ADDENDUM NO. 001

Architects Project No.: 23042

Project Name: Ralston Apartment Renovations

PLANS AND EXTERIOR ELEVATIONS

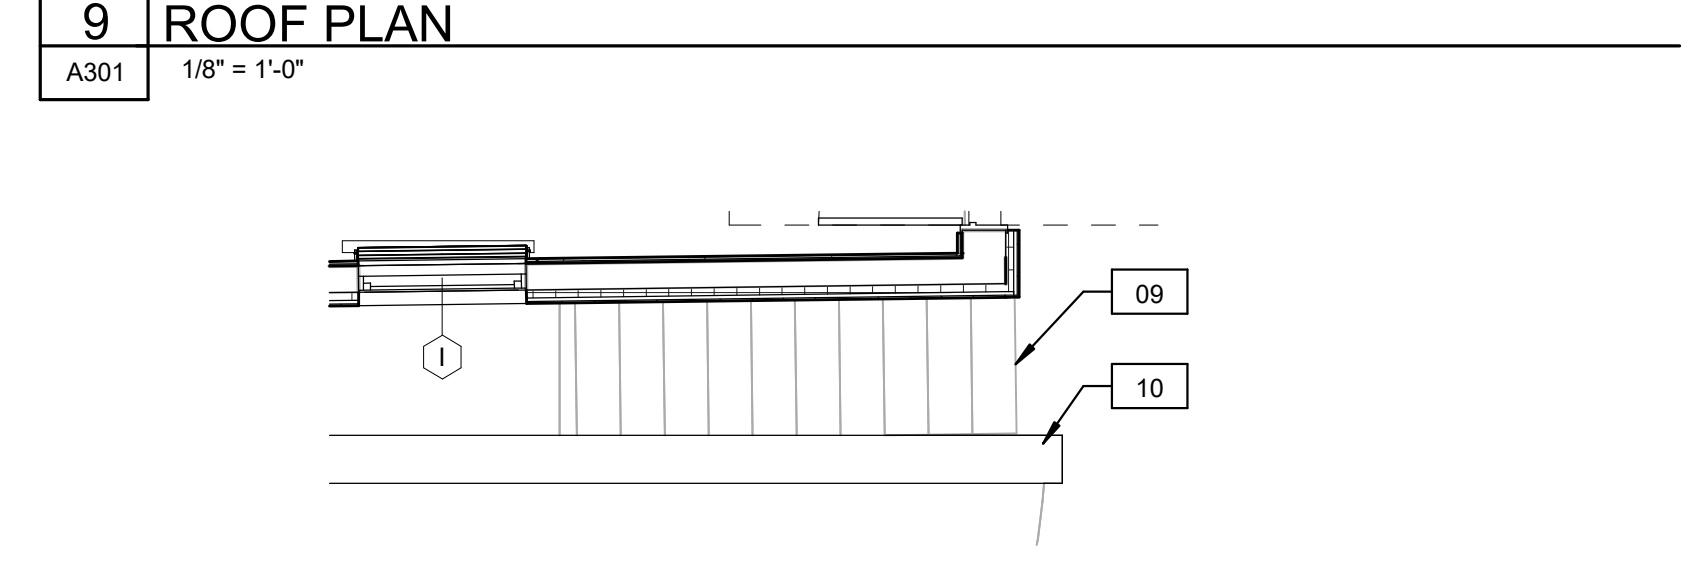
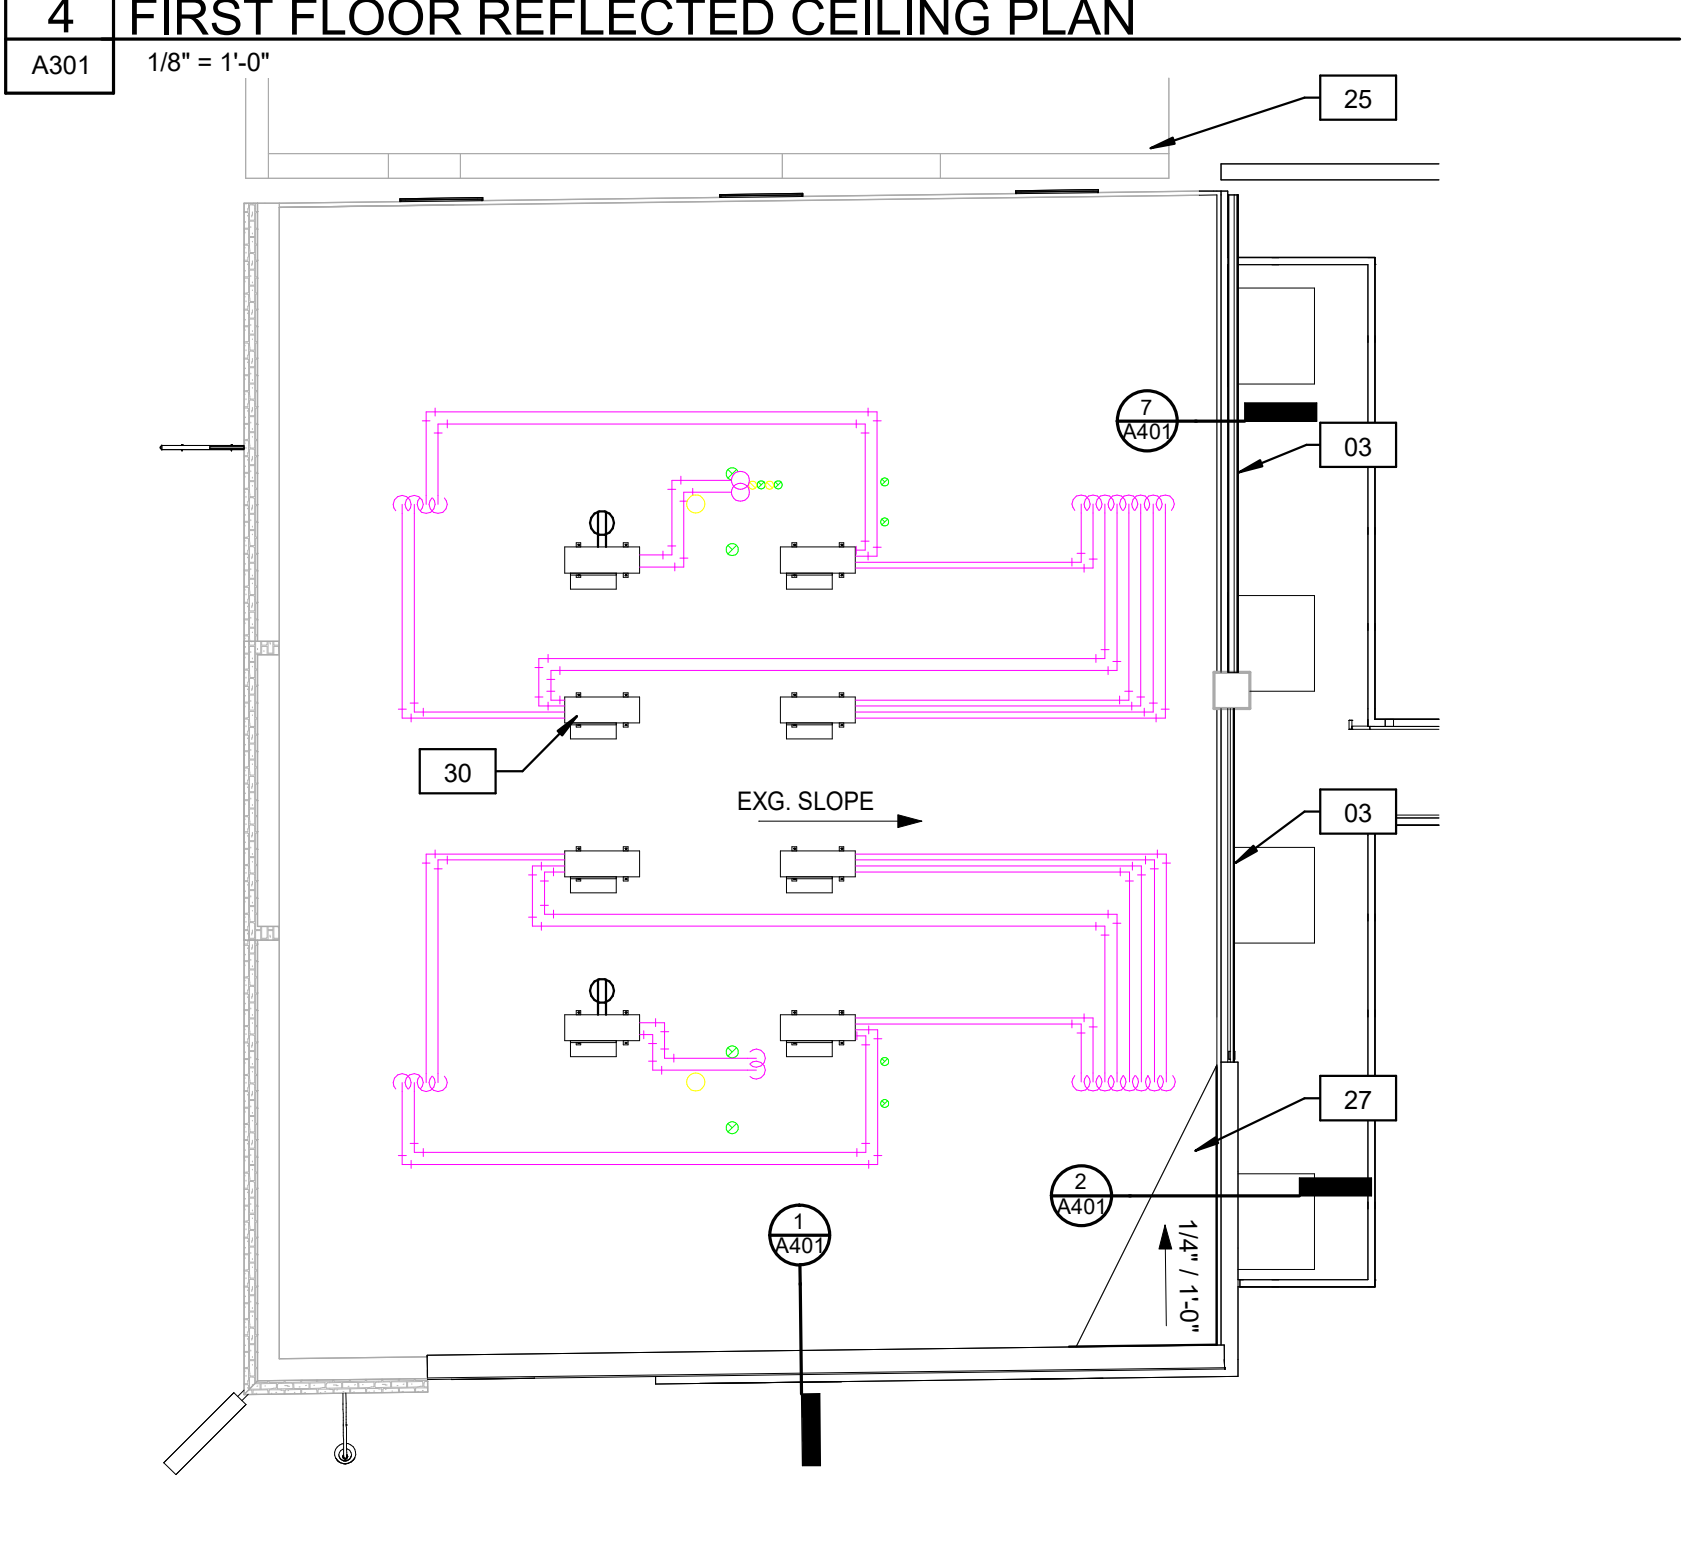
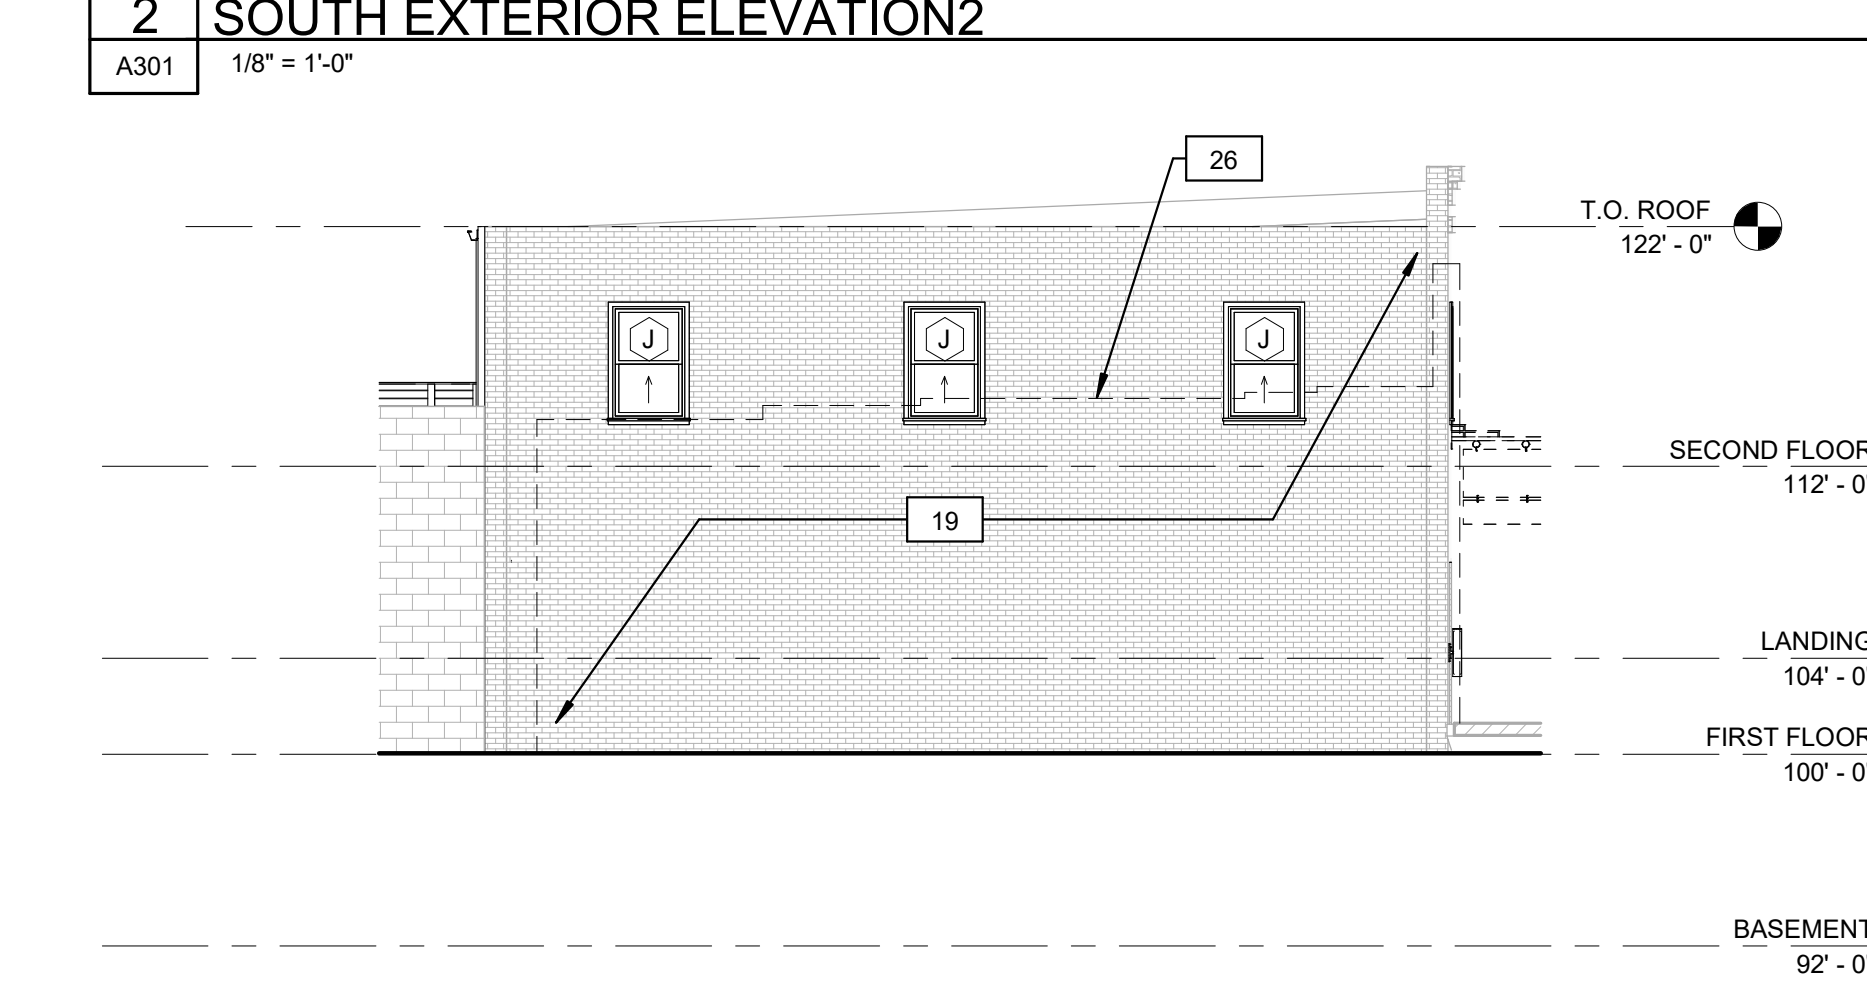
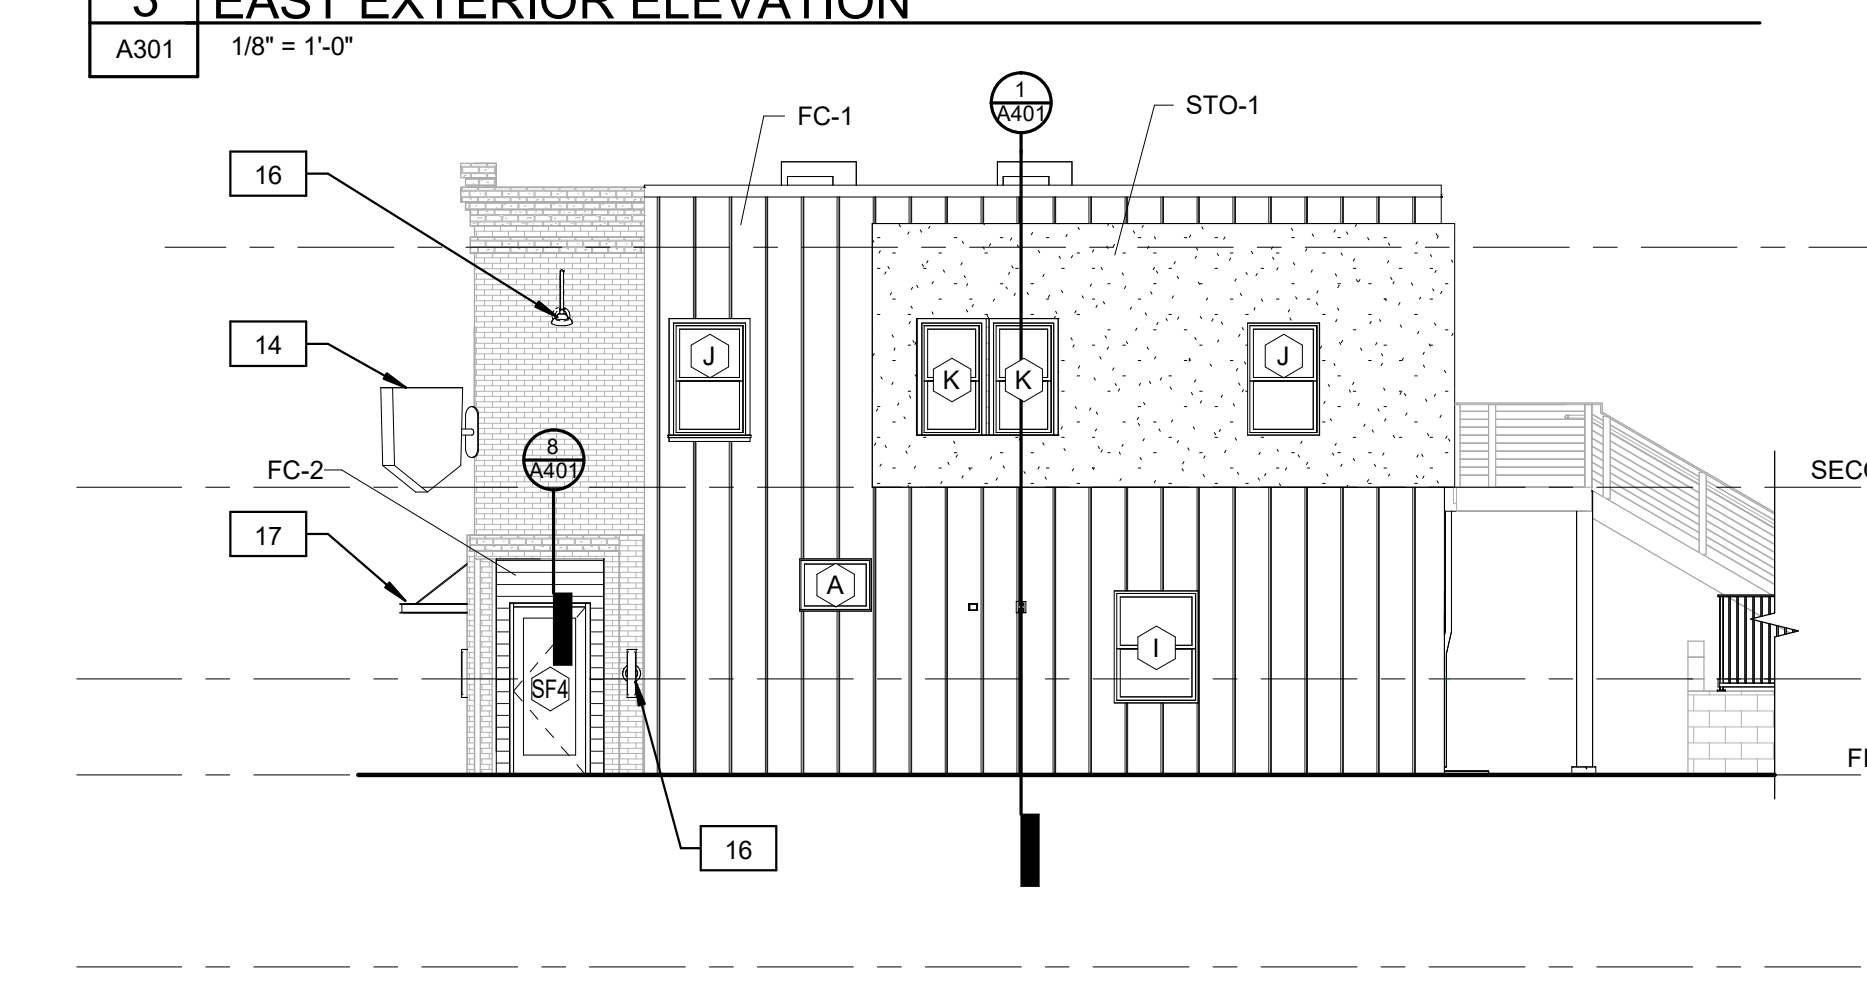
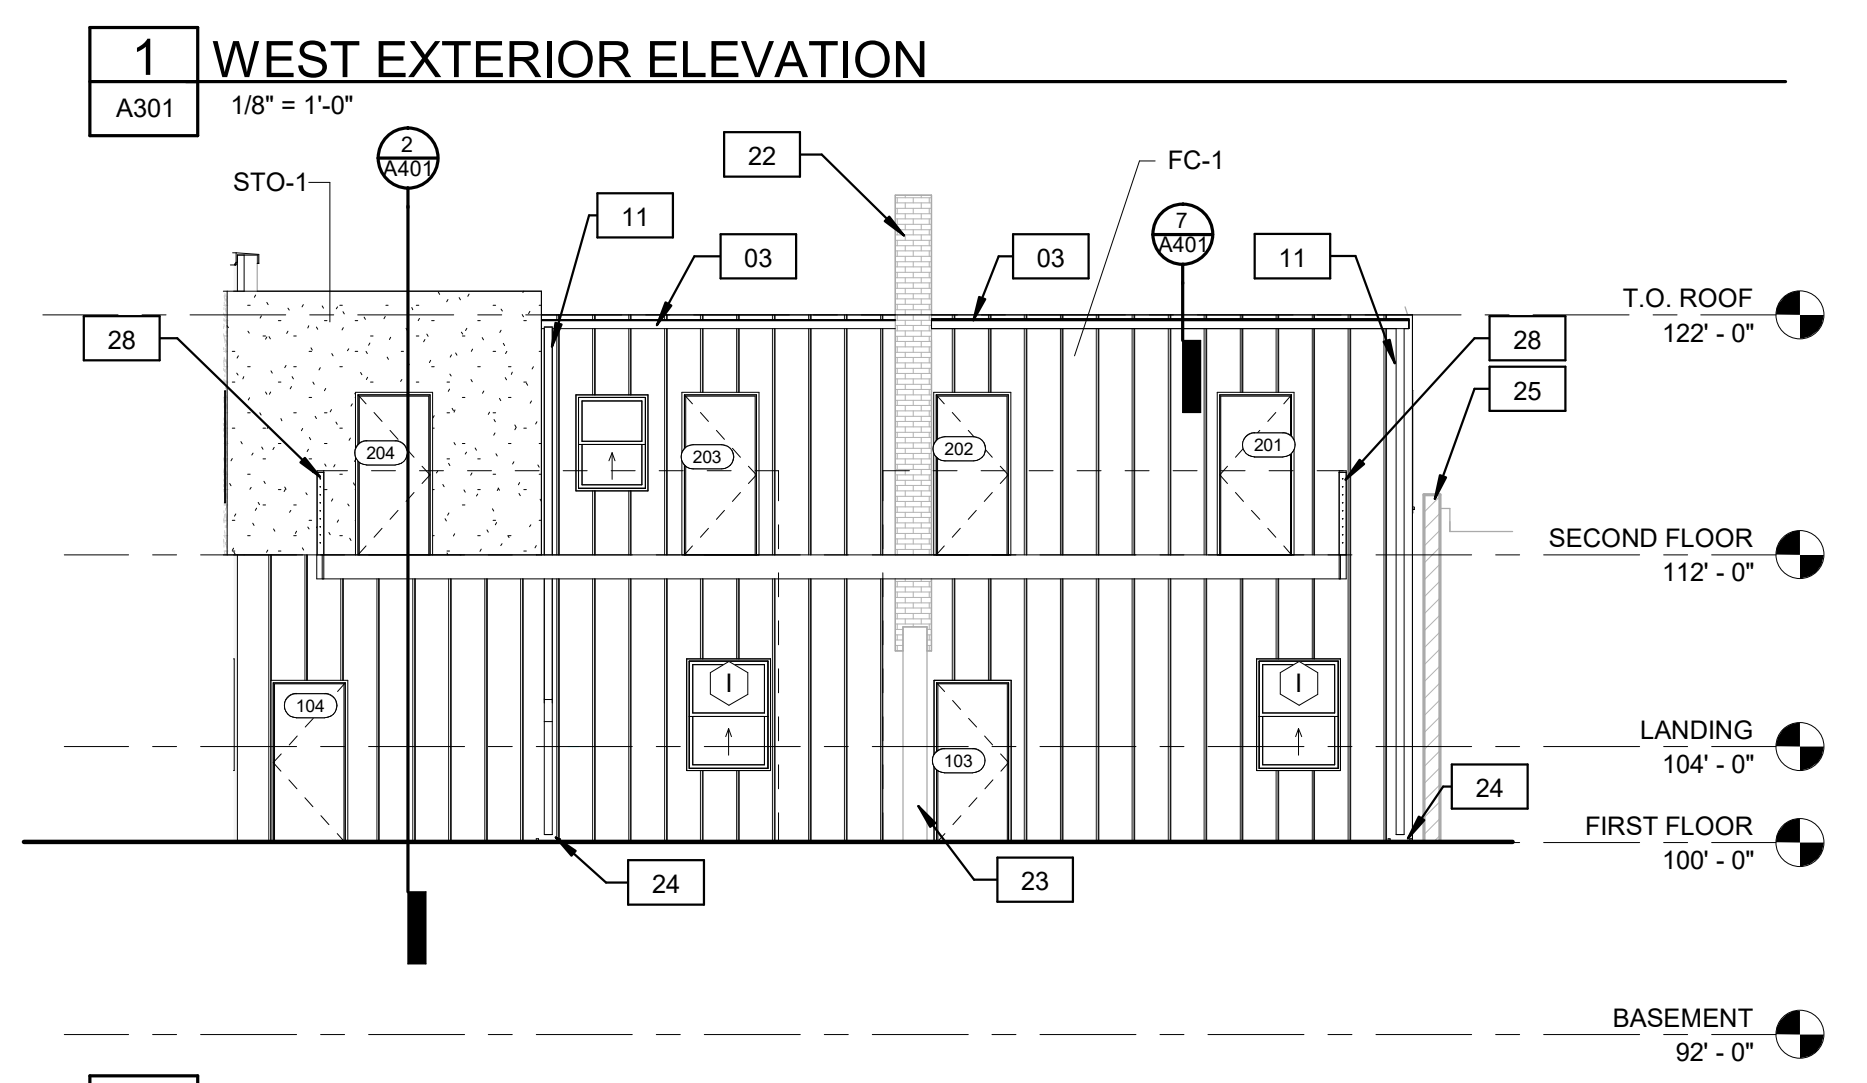
1. Is the roof being fully replaced? Please provide a roof spec if so.
 - a. Per keynote 27 on sheet A301, intention is to match and cricket into the existing roof.

5. Sheet - A301 PLANS AND EXTERIOR ELEVATIONS
 - a. Identified colors in finish legend for exterior finishes.
6. Sheet - A501 CASEWORK DETAILS
 - a. Added counter edge dimension to SSM material
